**TO:** Mayor Robert Price  
**ATTN TO:** Gewel Richardson, Planner II  
**FROM:** Douglas R. Hooker, Executive Director  
**RE:** Development of Regional Impact (DRI) Review

**Name of Proposal:** 300 Marketplace DRI #3252

**Review Type:** Development of Regional Impact

SITE PLAN - DRI NO. 3252 300 MARKETPLACE

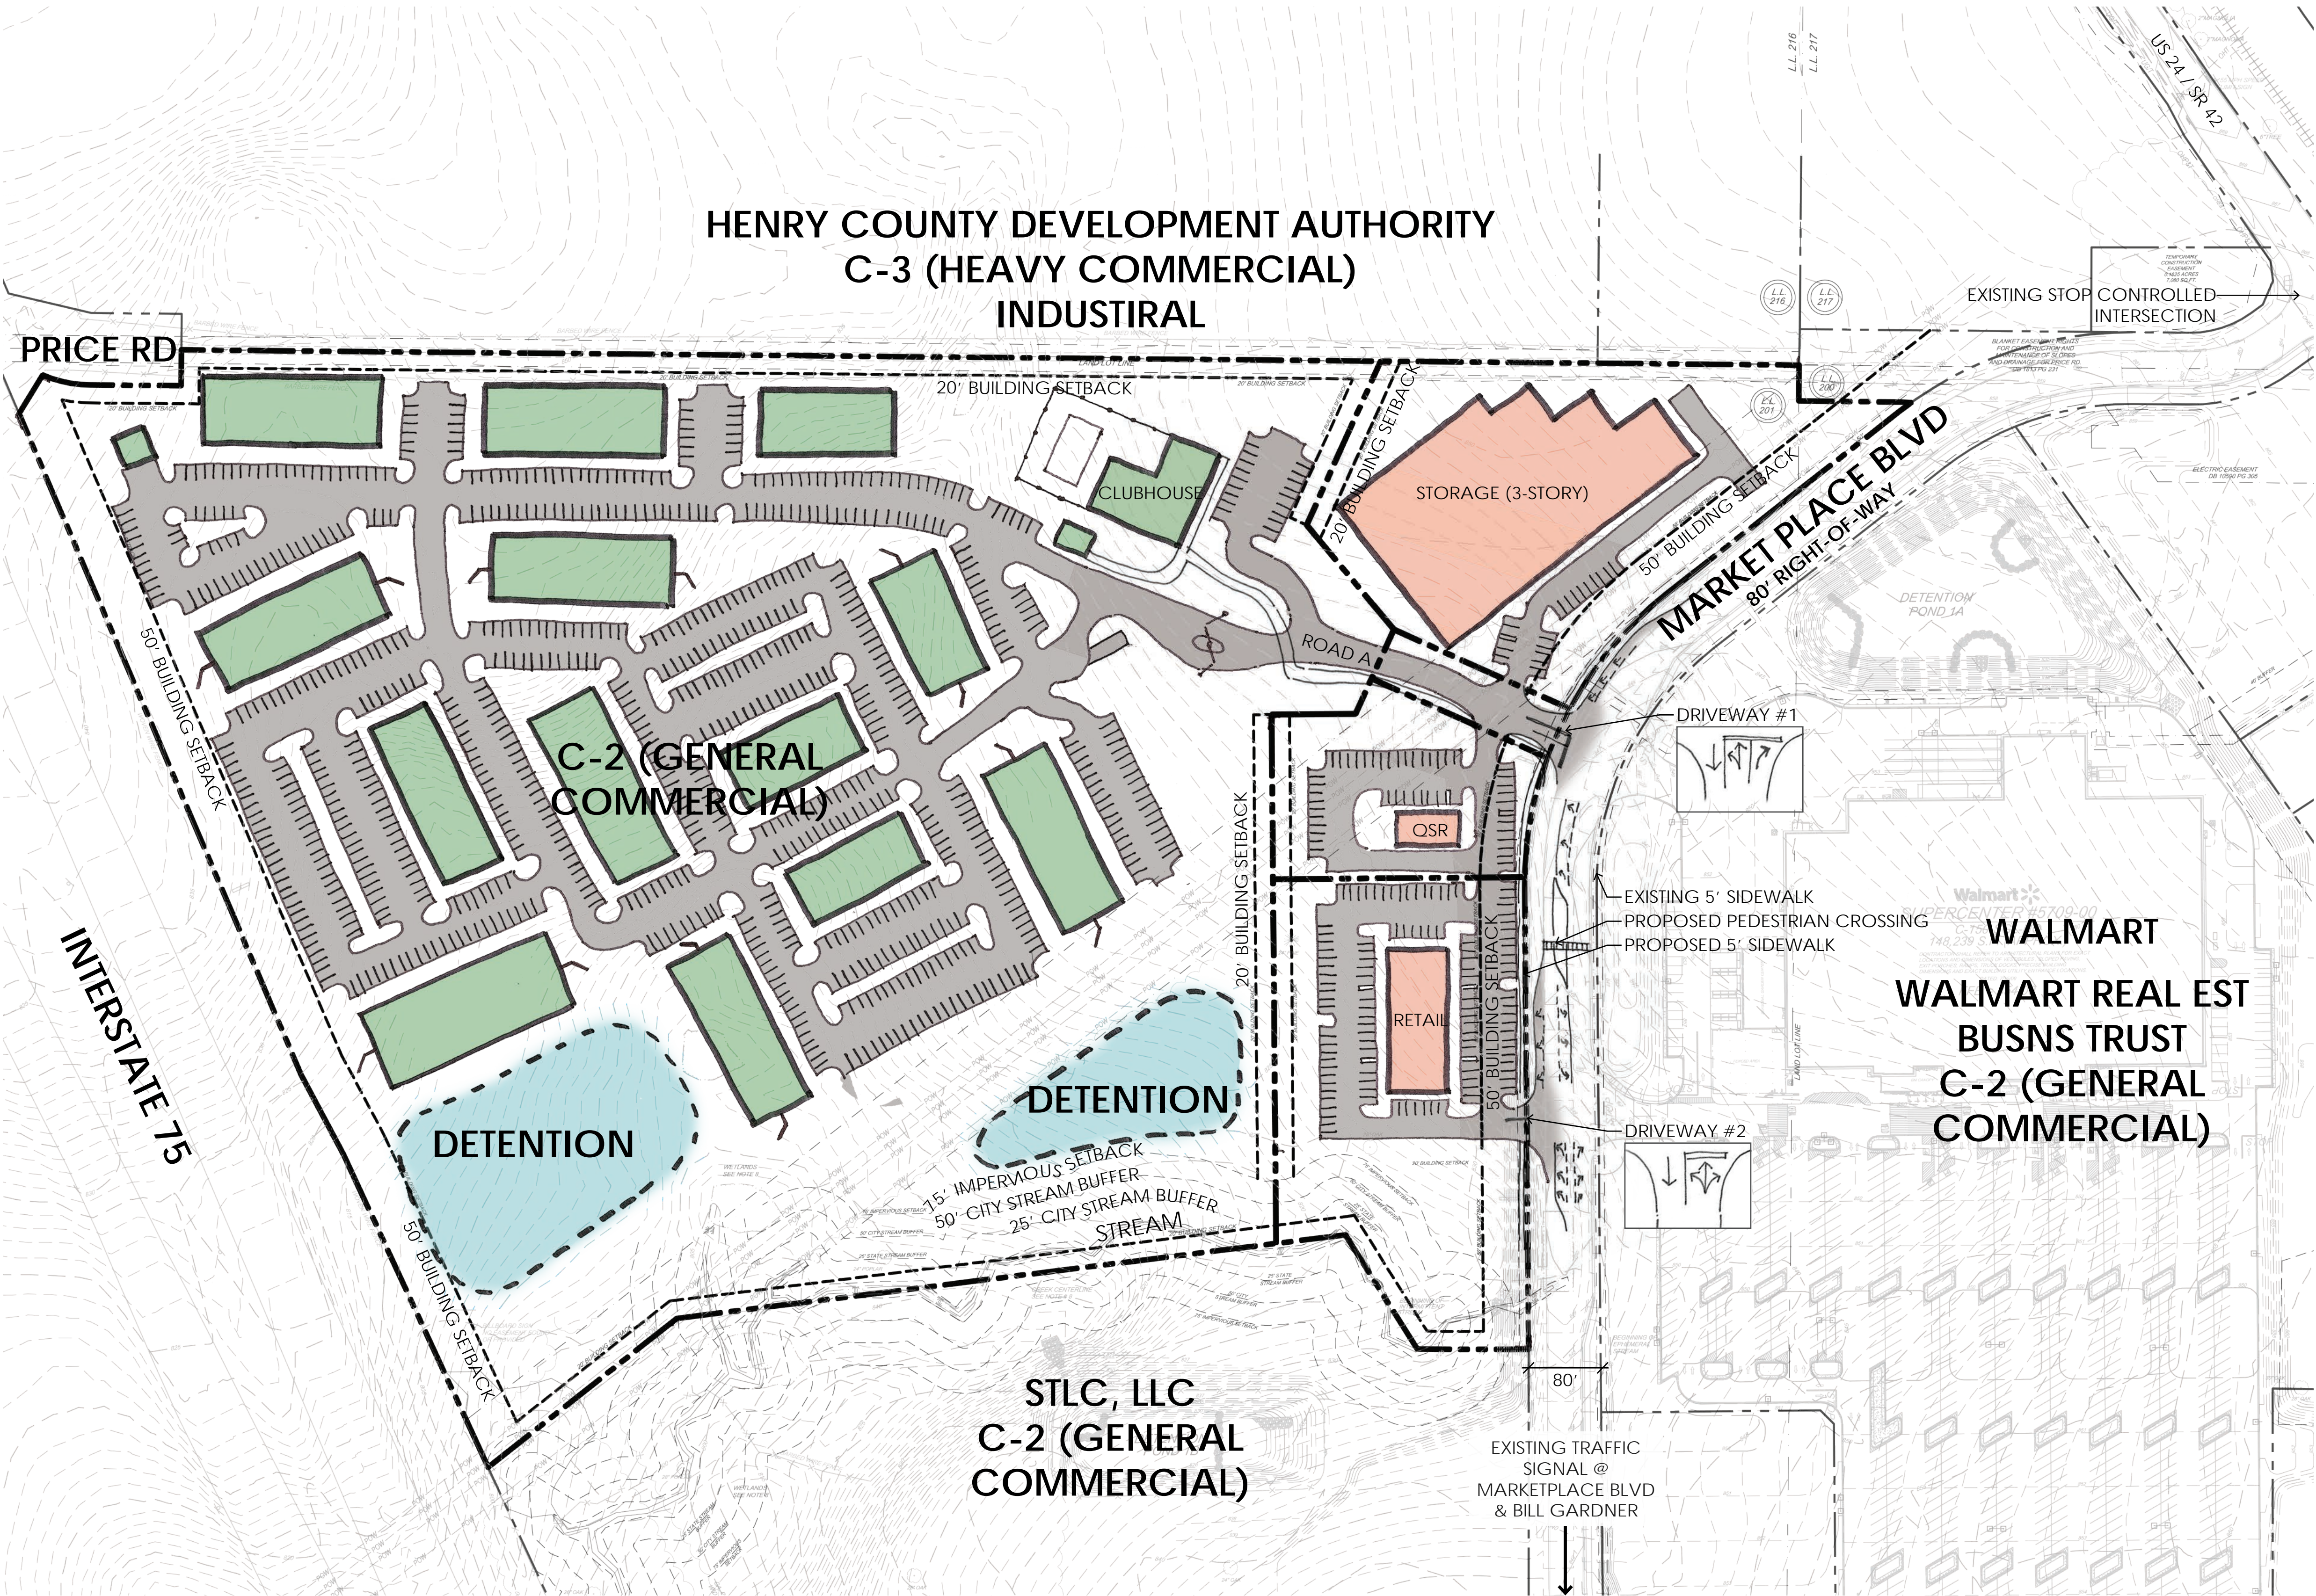
- The submitted site plan does not show pedestrian facilities and connections among uses within the site. These will likely be required under standard GRTA conditions.

frontages. Additional comments from ARC's Natural Resources Group are attached. They note that the entire site falls within the Indian Creek and Towaliga River Water Supply Watersheds and will be subject to relevant state and local laws. They also note that the submitted site plan does not currently show a blue line stream that is shown on USGS maps. This concern was echoed in the attached comment from Spalding County.

The site plan appears to disregard the presence of a stream that bisects the property. If this project is within the water supply protected watershed, the stream may have enhanced buffer requirements per Rule 391-3-16.

The USGS coverage for the project area shows a blue line stream running from the pond across Price Road from the project across the property to its western edge. This stream is not shown on the submitted site plan and the e submitted site plan does not show this stream, which appears to run through the General Commercial portion of the project. However, the site plan shows an unmapped stream along the southern edge of the property with the city's 50-foot buffer and 75-foot impervious setback shown as well as the 25-foot State Erosion and Sedimentation Act buffer. No intrusions into those buffers is shown.

The proposer should clarify pedestrian and bicycle accommodations within the development and clarify the connection with the proposed Market Place Blvd. crossing.
